02/20/2018 HEART'S PLACE Applicant's Response to PUD Amendment Round 1 of Departmental Comments

Re: 120-122 W Boeger Drive – PUD Amendment Round 1 (PC#17-014) Hearts Place

Exhibit A

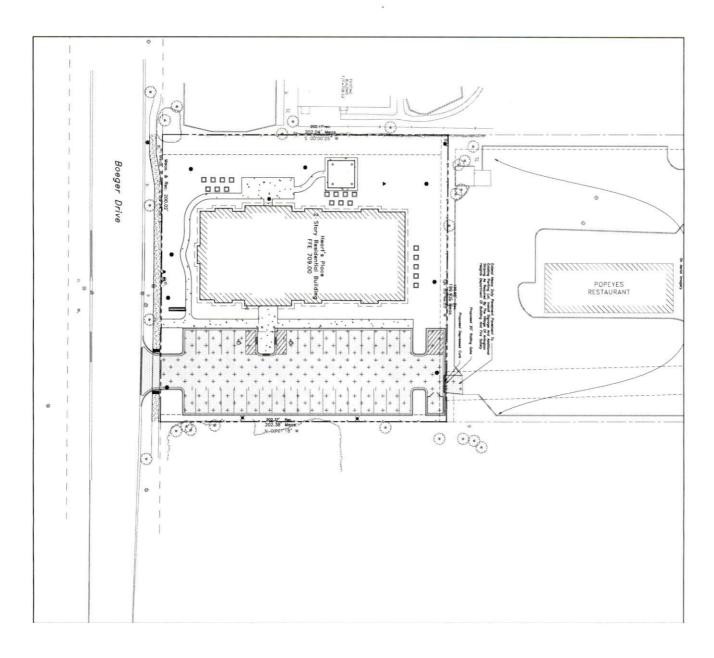
Employees, representatives, contractors, sub-contractors, and other similar agents of Heart's Place, LLC, being the owner and developer of Heart's Place Apartments, a residential development to be located at 120 W. Boeger Drive in Arlington Heights, Illinois (the "<u>Development Property</u>"), performing any and all work necessary to construct those improvements requisite to satisfy the easement granted to the Village of Arlington Heights for ingress/egress across the Easement Property, such work being described as the installation and construction of an asphalt paver connection across the northeast end of the Development Property across the southeast end of the Easement Property, as to create a paved connection for the ingress/egress of the Village Fire Department's vehicles, such connection being further identified on Exhibit A attached hereto.
